ADDENDUM NO. 1
PROJECT MANUAL
PANOLA COUNTY
CARTHAGE, TEXAS
2026 AIRPORT ELECTRICAL AND PAVEMENT IMPROVEMENTS
TXDOT CSJ NO. 2619CARTH

This Addendum to the Project Manual is issued to modify, explain, or correct the original Contract Documents and Specifications for 2026 Airport Electrical and Pavement Improvements (TXDOT CSJ No. 2619CARTH) and is hereby made part of the Contract Documents. Acknowledgement of receipt of the addendum is required on the signature page of the Bid Form. Failure to acknowledge all addenda could render your Bid out of form and result in a non-responsive Bid.

Dated at Brenham, Texas
April 22, 2026

VAULT DETAILS - I
CARTHAGE, TEXAS
PANOLA COUNTY AIRPORT - SHARPE FIELD
2026 AIRPORT ELECTRICAL AND PAVEMENT IMPROVEMENTS

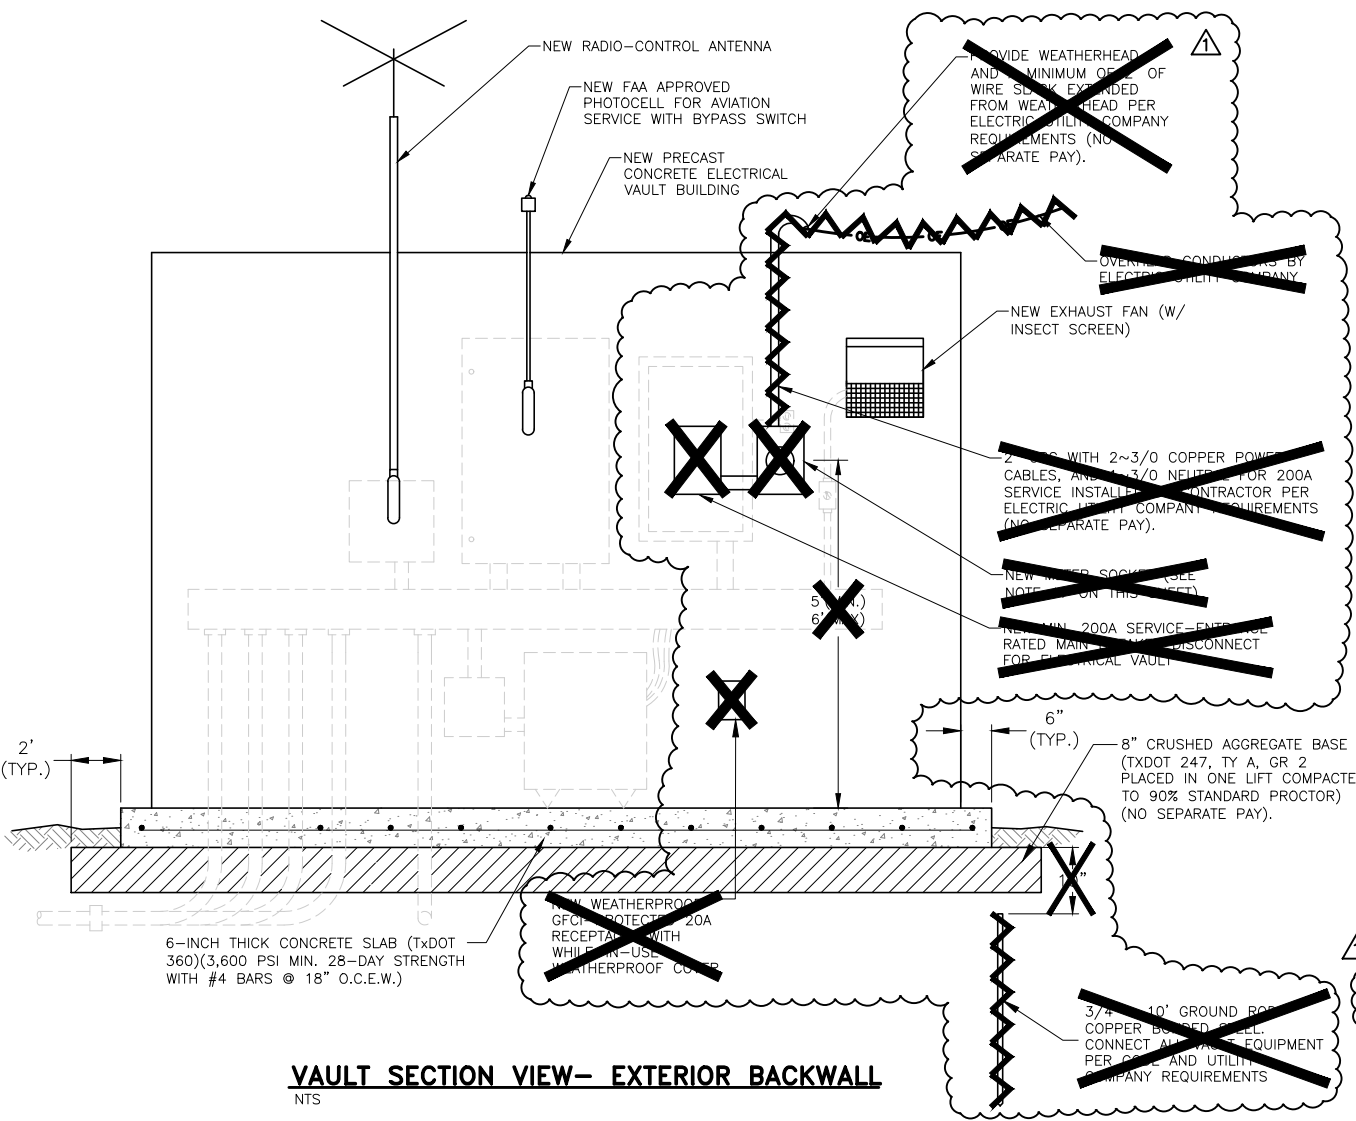
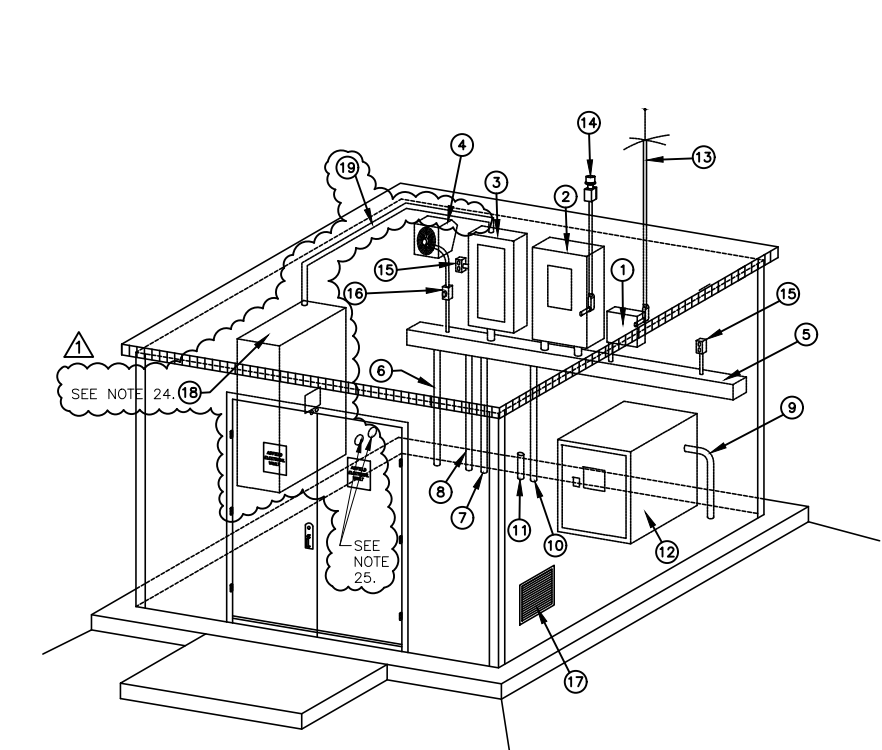
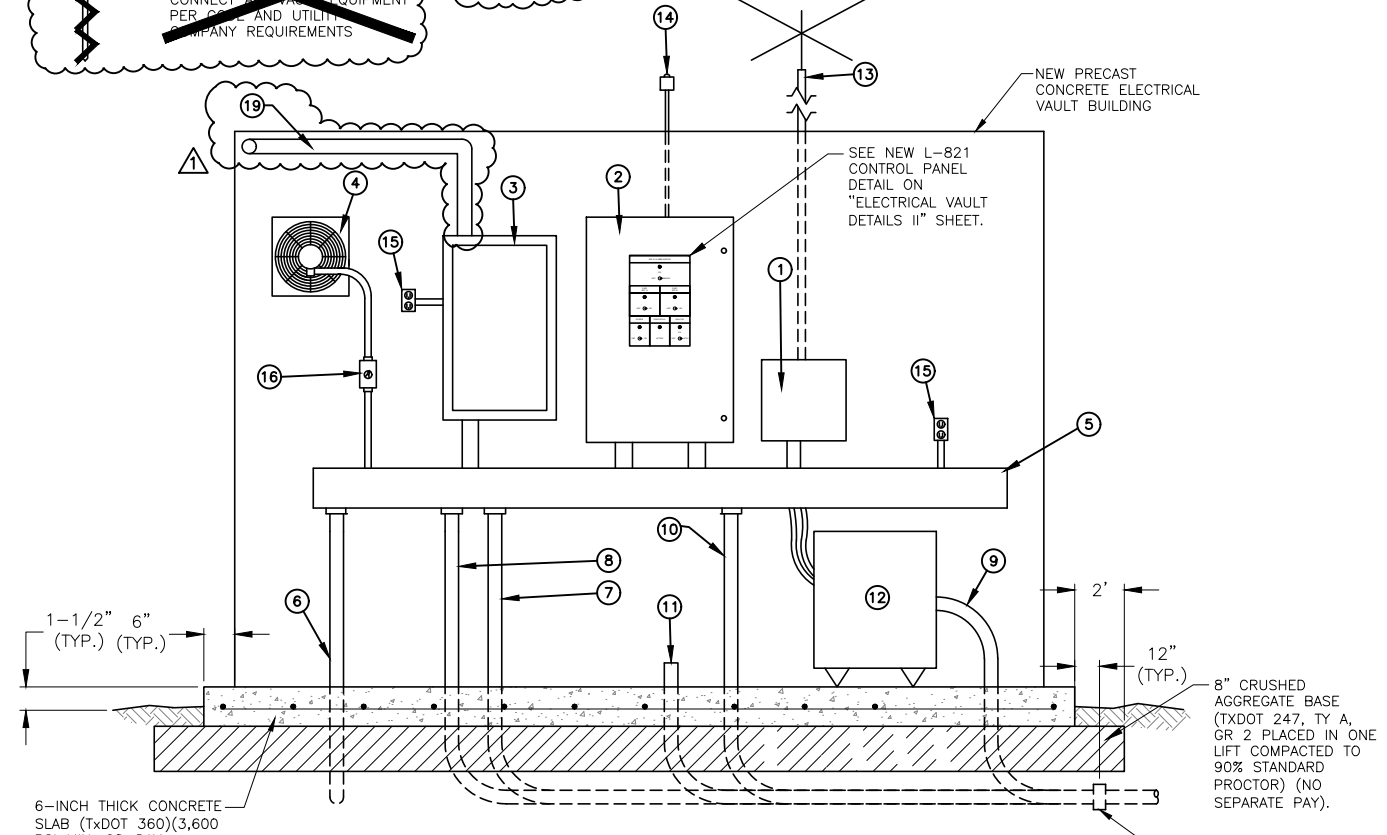
3. SHEET NO. 85–VAULT DETAILS–I

REPLACE Sheet No. 85 with the attached revised Sheet No. 85.

- BUILDING TO BE ATTACHED TO CONCRETE SLAB FOUNDATION USING 1/2" x 4-1/4" WEDGE STYLE CONCRETE ANCHORS @ 24" O.C. BUILDING TO INCLUDE: 1/4" x 4" NEOPRENE GASKET BETWEEN BUILDING BOTTOM AND CONCRETE SLAB, TWO 4", INDUSTRIAL LED FIXTURES DESIGNED TO PROVIDE 40-FOOT-CANDLE AVERAGE LIGHT LEVEL AND SUITABLE FOR OPERATION DOWN TO 0 DEGREES FAHRENHEIT, A THERMOSTATICALLY-CONTROLLED EXHAUST FAN SIZED PER THE MANUFACTURER AND INCLUDING AN INSECT SCREEN, AND A LOUVERED FRESH AIR INTAKE INCLUDING AN INSECT SCREEN. THE EXHAUST FAN SHALL BE PLACED TOWARD THE TOP OF THE BUILDING AND THE FRESH AIR INTAKE TOWARDS THE BOTTOM. THE EXHAUST AND INTAKE SHALL BE DIAGONALLY OPPOSITE EACH OTHER IN THE VAULT.

- CONTRACTOR TO PROVIDE AND INSTALL A 6' SQUARE, 6" THICK REINFORCED CONCRETE SLAB CENTERED ON DOORWAY FOR EXTERIOR SWINGING VAULT DOORS.
- VAULT LAYOUT IS TYPICAL. ACTUAL LAYOUT MAY VARY FROM THAT SHOWN TO MEET CODE AND MANUFACTURER RECOMMENDATIONS.

- CONTRACTOR SHALL CONFIRM AVAILABLE FAULT CURRENT WITH ELECTRIC UTILITY COMPANY, AND PROVIDE MAIN DISCONNECT, AUTOMATIC TRANSFER SWITCH, AND LIGHTING PANEL WITH APPROPRIATE FAULT CURRENT INTERRUPTING RATINGS.

VAULT DETAILS - II
 CARTHAGE, TEXAS
 PANOLA COUNTY AIRPORT - SHARPE FIELD
 2026 AIRPORT ELECTRICAL AND PAVEMENT IMPROVEMENTS

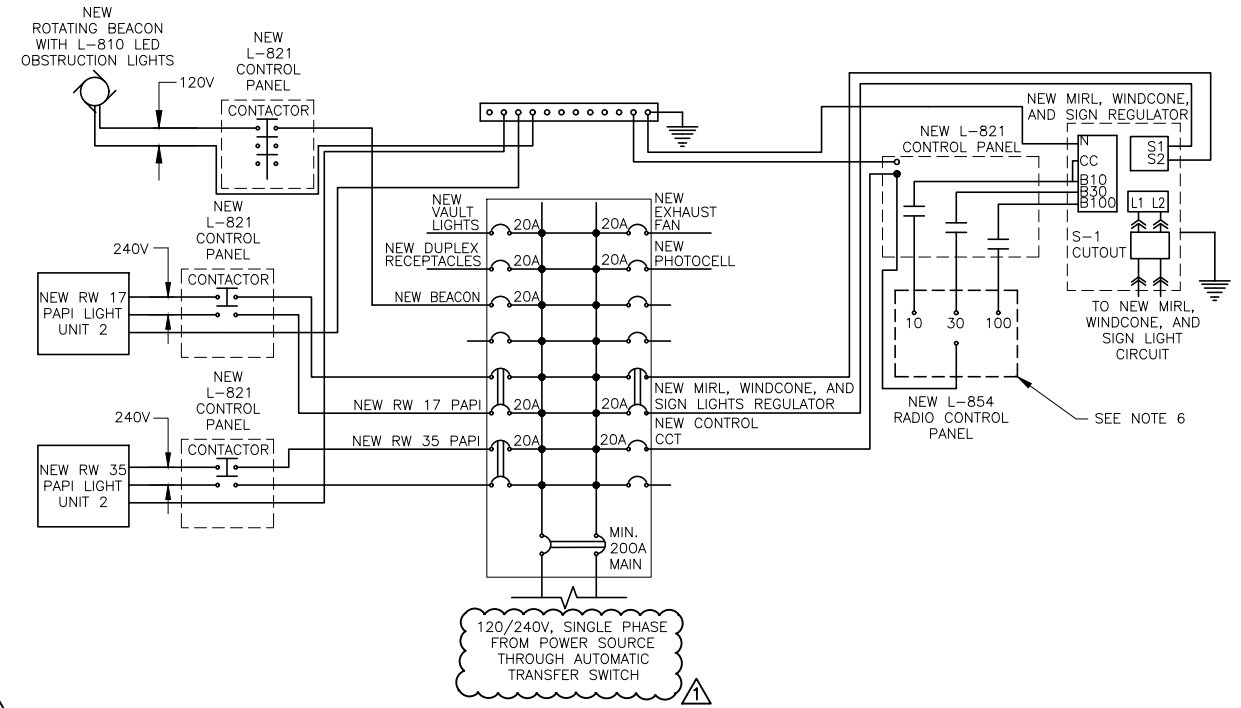
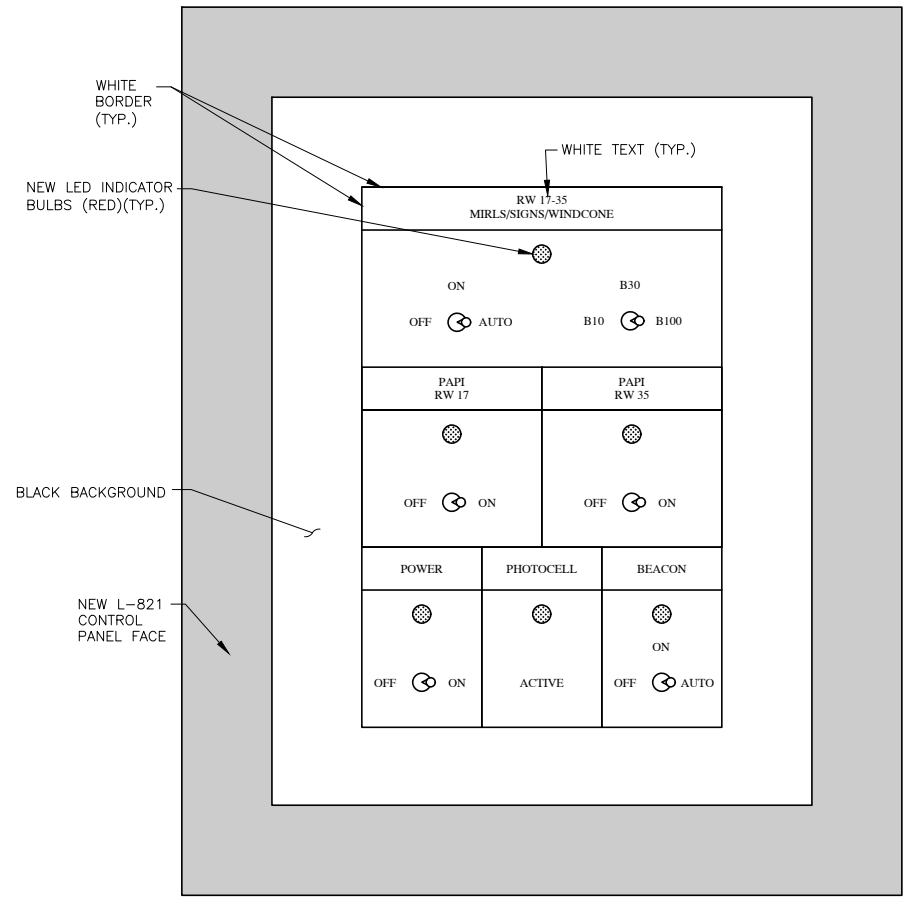
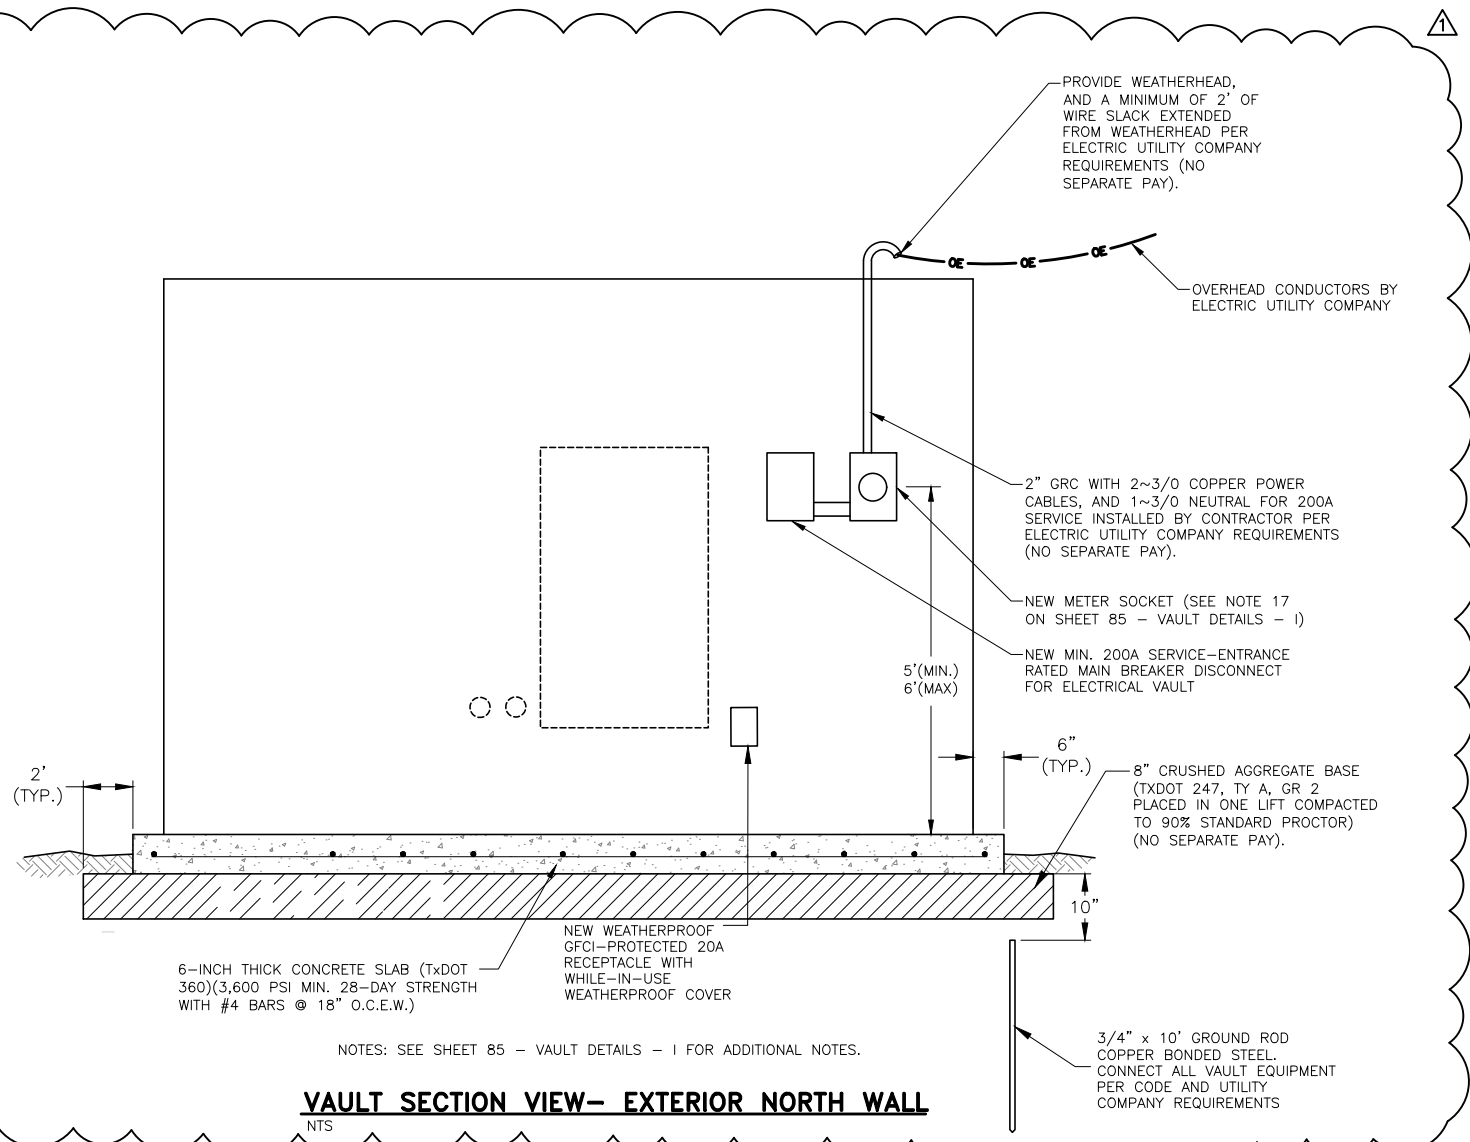
4. SHEET NO. 86–VAULT DETAILS–II

REPLACE Sheet No. 86 with the attached revised Sheet No. 86.

1. CONTRACTOR SHALL SUBMIT WIRING DIAGRAM TO THE ENGINEER PRIOR TO BEGINNING ELECTRICAL WORK FOR APPROVAL.
2. WIRING DIAGRAM IS TYPICAL. ACTUAL WIRING MAY VARY FROM THAT SHOWN. SEE MANUFACTURER'S INSTRUCTIONS.

3. PHOTOCELL WIRING NOT SHOWN FOR CLARITY OF DRAWING. PHOTOCELL SHALL CONTROL MIRL, WINDCONE, SIGN, AND BEACON CIRCUITS. PHOTOCELL SHALL FACE TRUE NORTH. RW LIGHTS SHALL ACTIVATE TO LOWEST INTENSITY WHEN THE PHOTOCELL IS ENERGIZED.

4. L-821 CONTROL PANEL WIRING NOT SHOWN FOR CLARITY OF DRAWING. CONTROL PANEL SHALL CONTROL: MIRL, WINDCONE, SIGNS, BEACON, AND BOTH PAPI SYSTEMS.
5. CONNECT BEACON, RUNWAY 17 PAPI, RUNWAY 35 PAPI, AND MIRLS, WINDCONE, AND SIGNS TO SEPARATE BUSBARS.
